RHODE ISLAND DEPARTMENT OF TRANSPORTATION

RHODE ISLAND CONTRACT NO.2013-CH-018

Trestle Trail - East Section

ADDENDUM NO. 1 Prospective bidders and all concerned are hereby notified of the following changes in the Plans, Specifications, Proposal and Distribution of Quantities for this contract. These changes shall be incorporated in the Plans, Specifications, Proposal and Distribution of Quantities, and shall become an integral part of the Contract Documents.

TYPICAL SECTIONS NO. 1, SHEET 7 OF 150
 ADD THE FOLLOWING TABLE

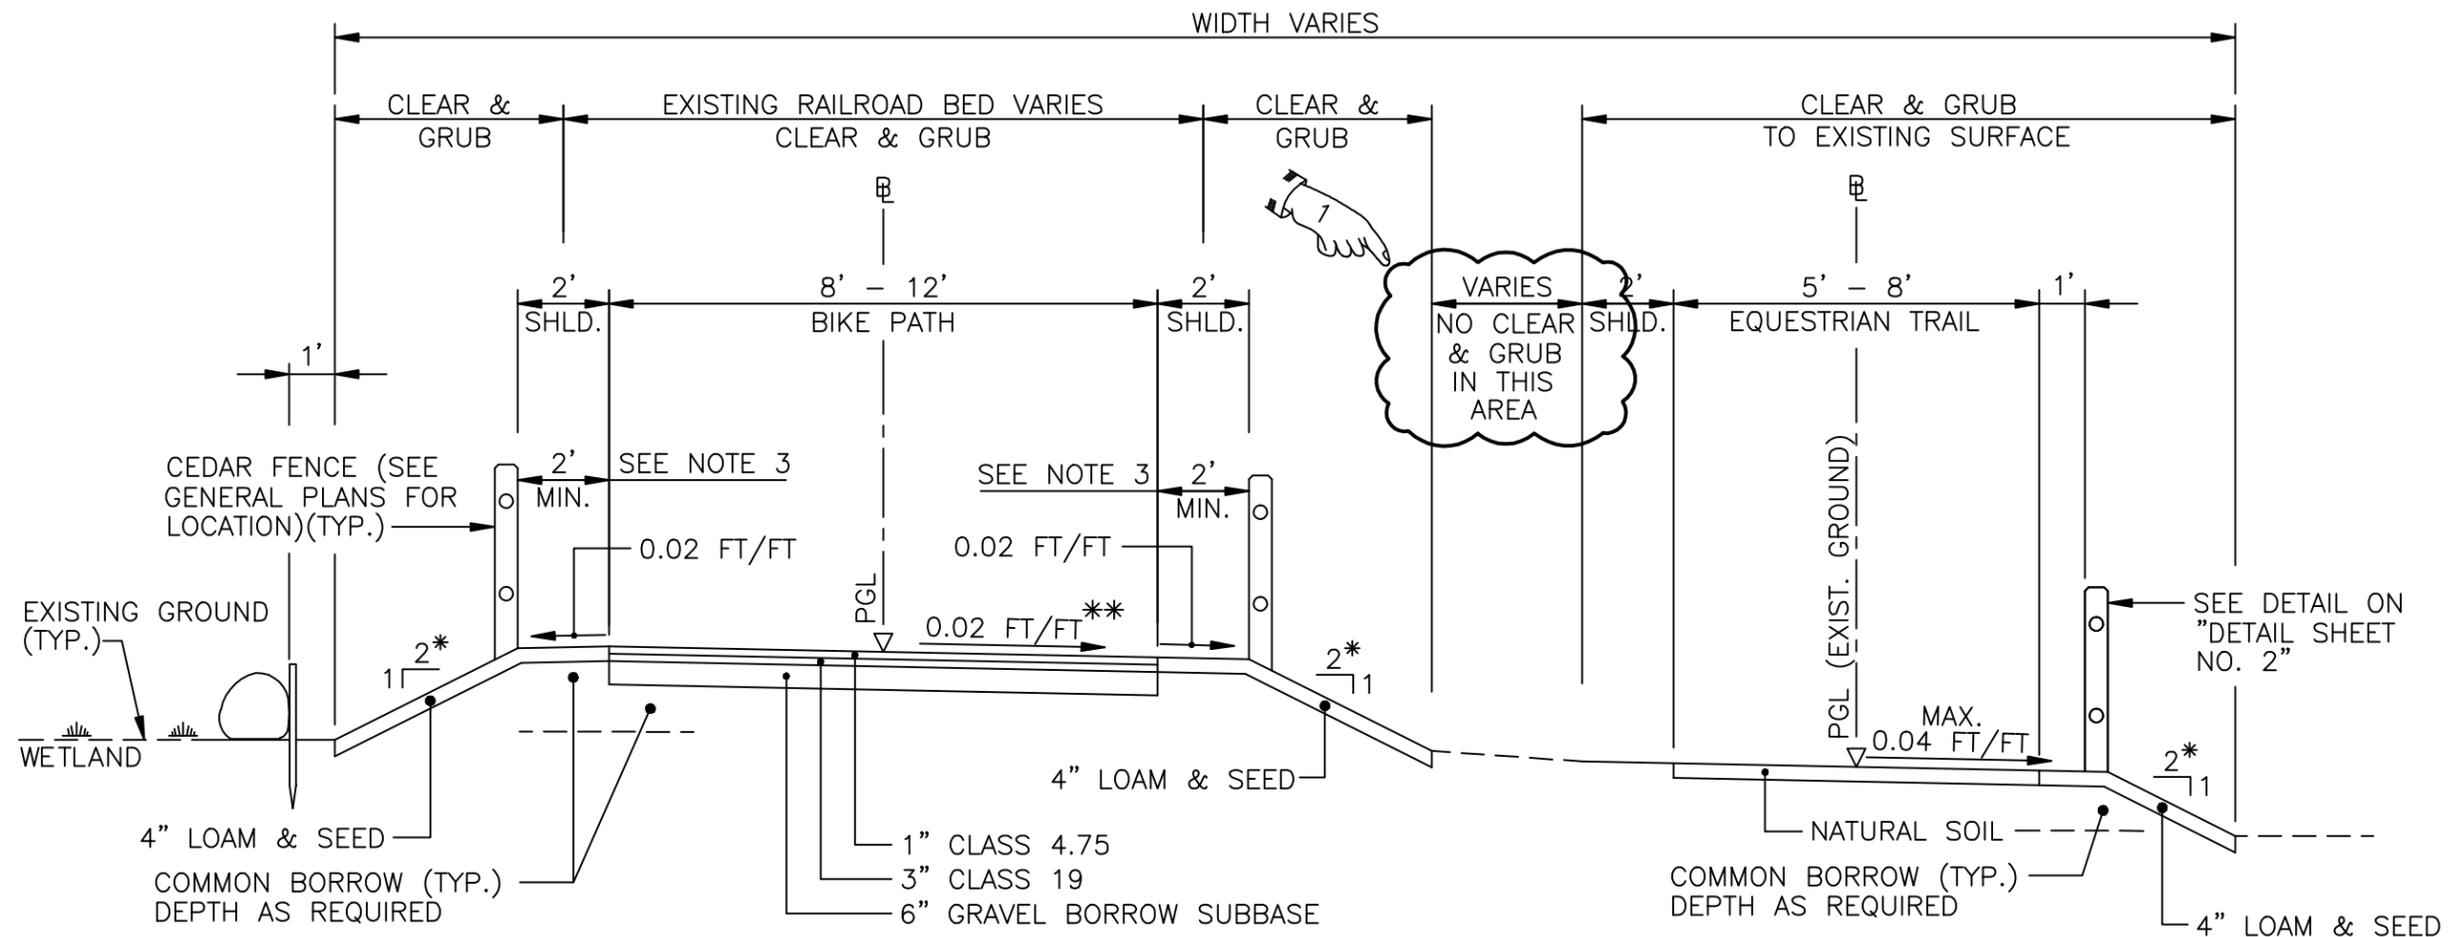
1. Typical Sections No. 1 Sheet 7 of 150
 - a. Modify this sheet as shown on Sketch No. 9 attached to this Addendum No. 1. A new table for Equestrian Trail Surface Material has been added.
 - b. Modify this sheet as shown on Sketch No. 10 attached to this Addendum No. 1. Replace "Shared-Use Path and Equestrian Trail (Fill Section)" with new revised Typical Section.

TABLE - EQUESTRIAN TRAIL SURFACE MATERIAL			
4" STONE FINES:		NATURAL SURFACE:	
STA. 500+00 TO	STA. 612+42	STA. 612+42 TO	STA. 614+18
STA. 614+18 TO	STA. 614+95	STA. 614+95 TO	STA. 621+95
STA. 621+95 TO	STA. 625+04	STA. 625+04 TO	STA. 628+34
STA. 628+34 TO	STA. 629+11	STA. 629+11 TO	STA. 633+06
STA. 633+06 TO	STA. 633+52	STA. 633+52 TO	STA. 643+23
STA. 643+23 TO	STA. 644+18	STA. 644+18 TO	STA. 650+14
STA. 650+14 TO	STA. 655+48	STA. 655+48 TO	STA. 664+75
STA. 664+75 TO	STA. 665+66	STA. 665+66 TO	STA. 666+40
STA. 666+40 TO	STA. 667+78	STA. 667+78 TO	STA. 669+00
STA. 668+91 TO	STA. 669+74	STA. 669+74 TO	STA. 671+00
STA. 670+98 TO	STA. 686+58.57	STA. 751+00 TO	STA. 768+08
STA. 700+00 TO	STA. 751+09		
STA. 768+08 TO	STA. 769+09.24
